# FINAL DRAINAGE REPORT

**ORTON PIT  
17710 CO115  
El Paso County, Colorado 80926**

Please add PCD File No. CDR2211

**Date: July 12, 2022**

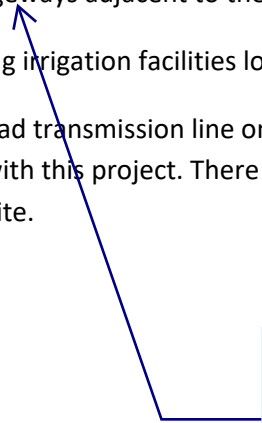
There is a FEMA floodplain (zone A) on the parcel, northeast of the site. Please be sure to mention this in your narrative.

INITIAL SUBMITTAL 07/12/22  
DRAWING SIZE 24" X 36"  
SURVEY FIRM SURVEY DATE  
JOB NO. 35059  
DRAWING NAME 35059 - Drainage Plans.dwg  
SHEET 01 OF 02  
DNG01

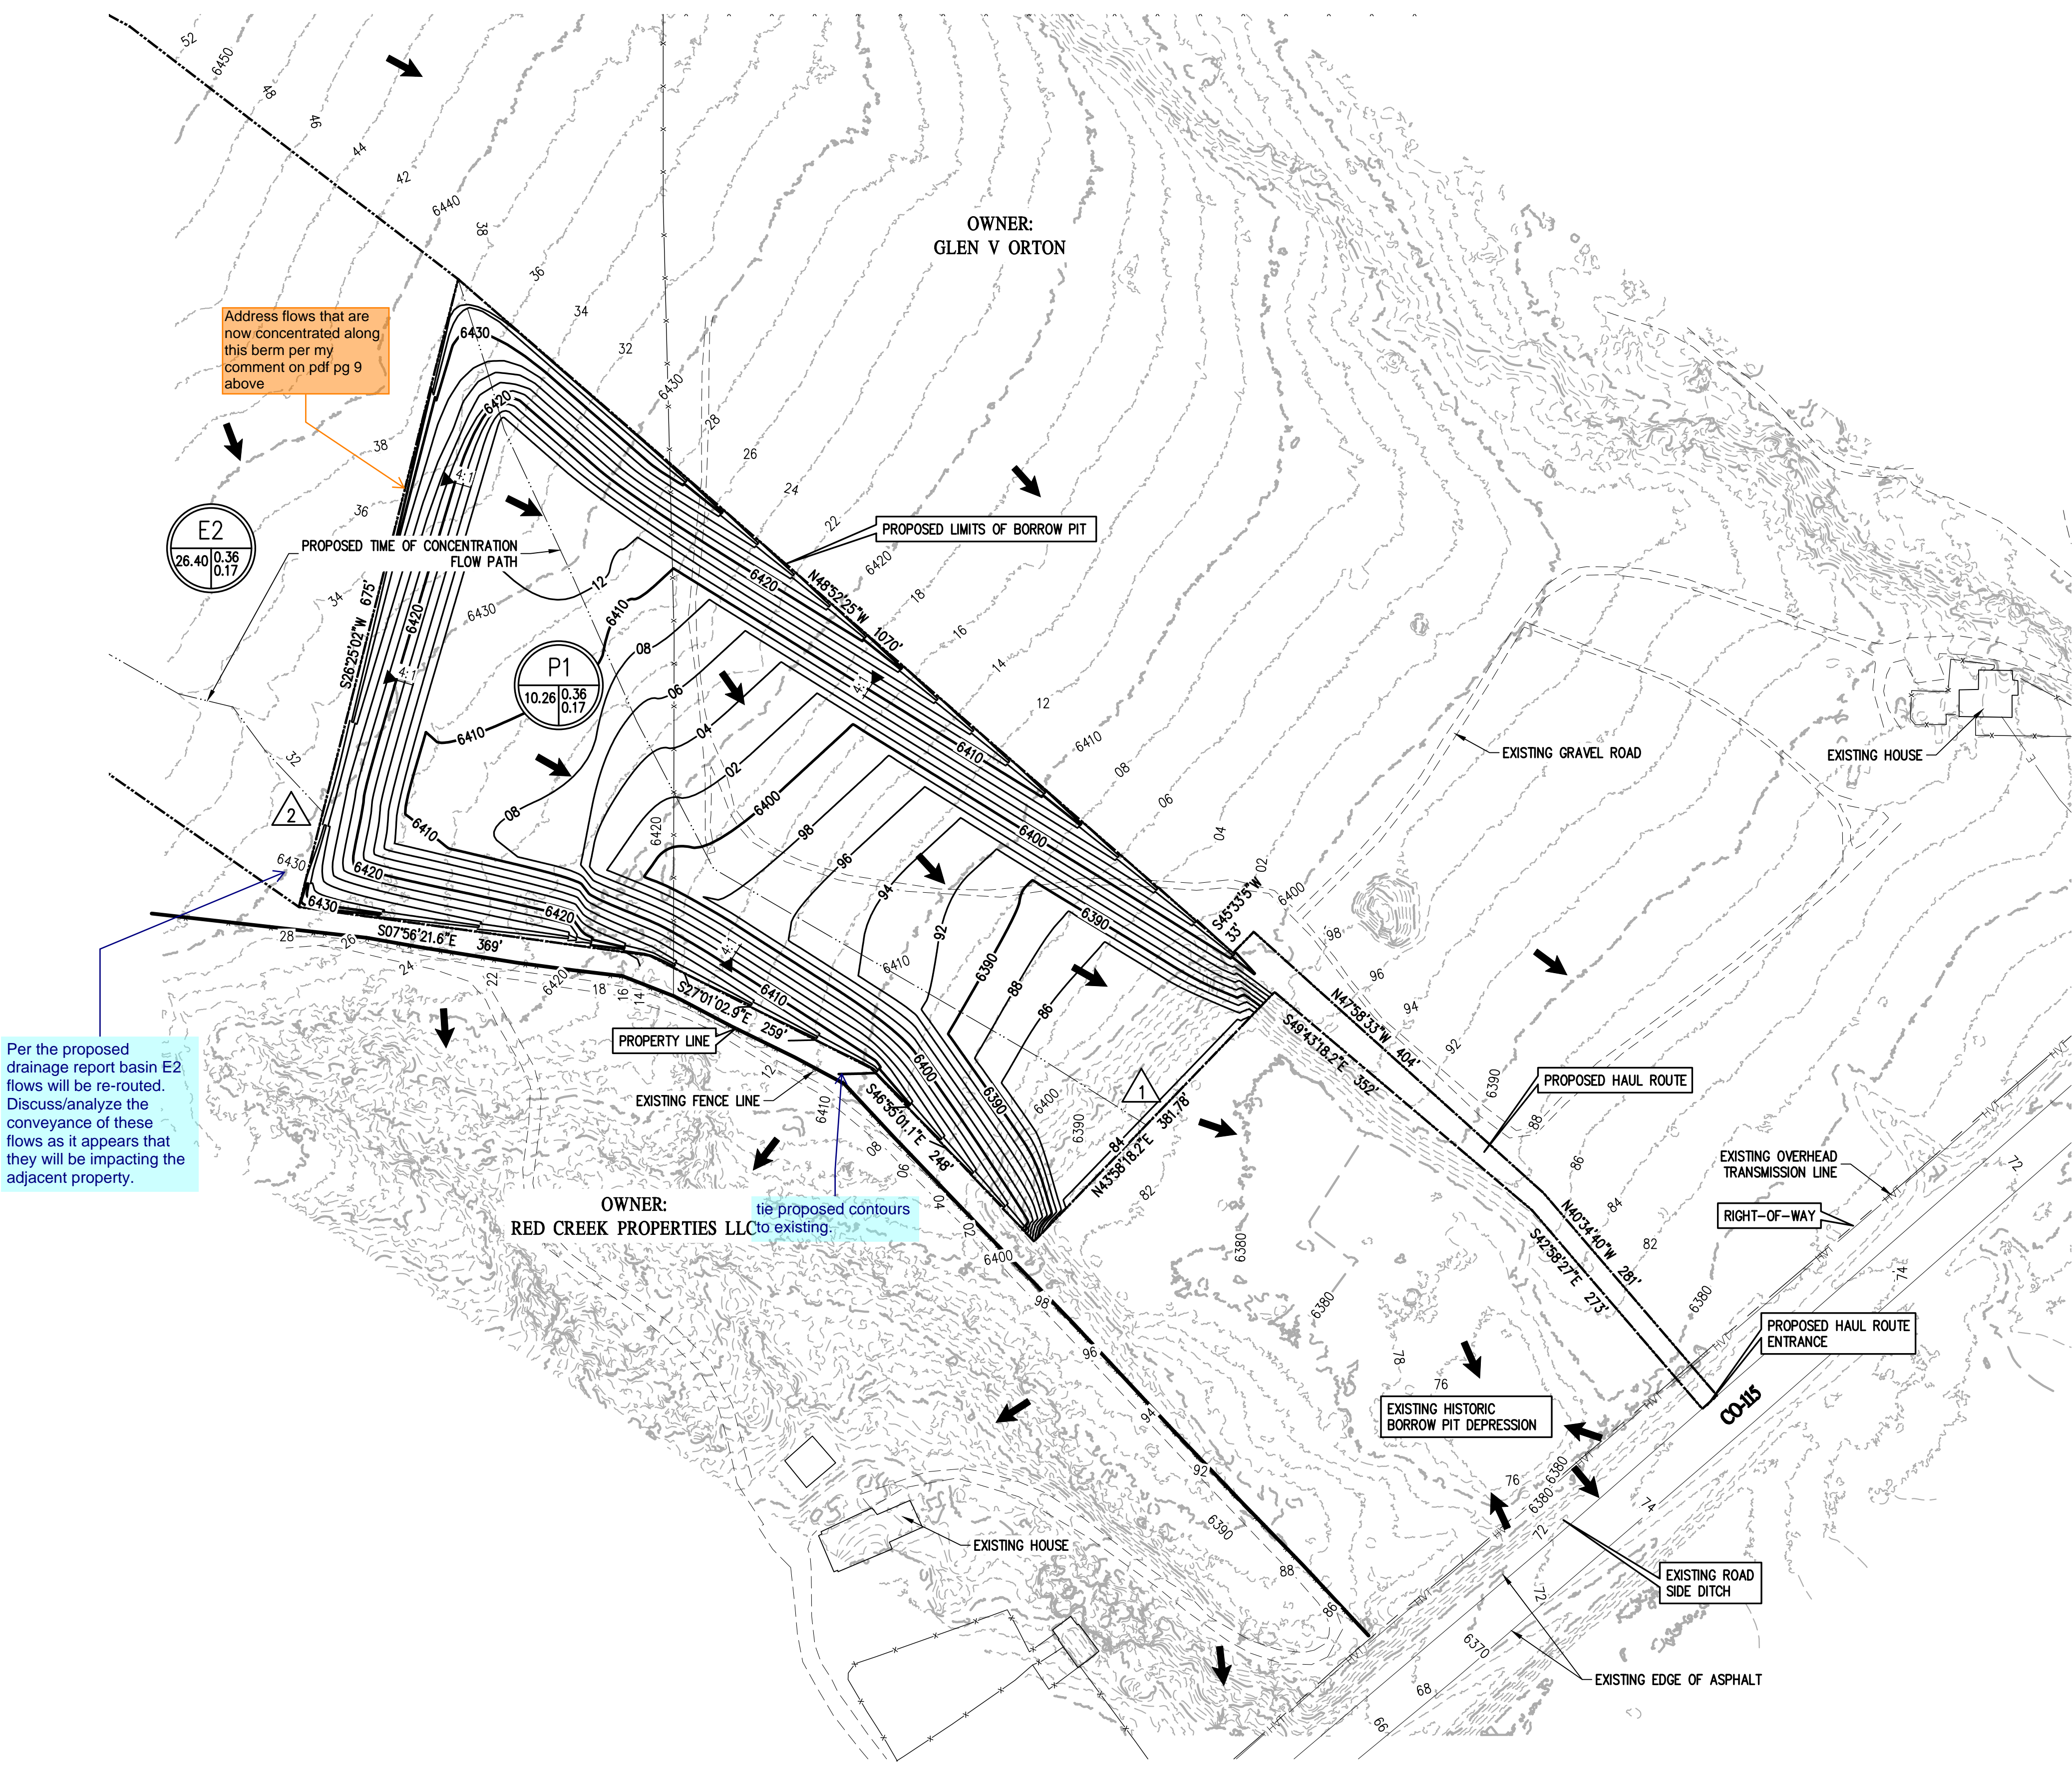
Please also show the cumulative flows entering the depression

INITIAL SUBMITTAL 07/12/22  
DRAWING SIZE 24" X 36"  
SURVEY FIRM SURVEY DATE  
JOB NO. 35059  
DRAWING NAME 35059 - Drainage Plans.dwg  
SHEET 02 OF 02  
DNG02

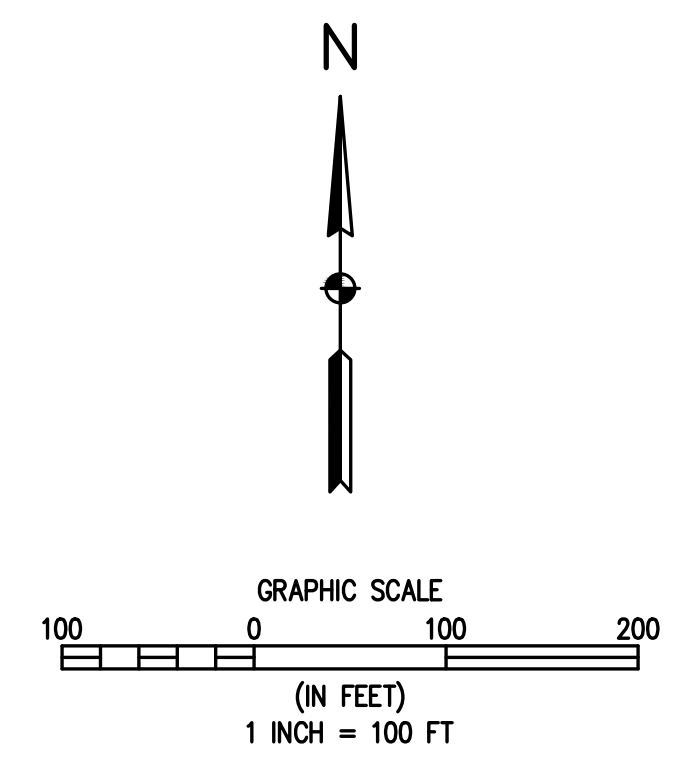
Address flows that are now concentrated along this berm per my comment on pdf pg 9 above

tie proposed contours to existing.

Please also show the cumulative flows entering the depression
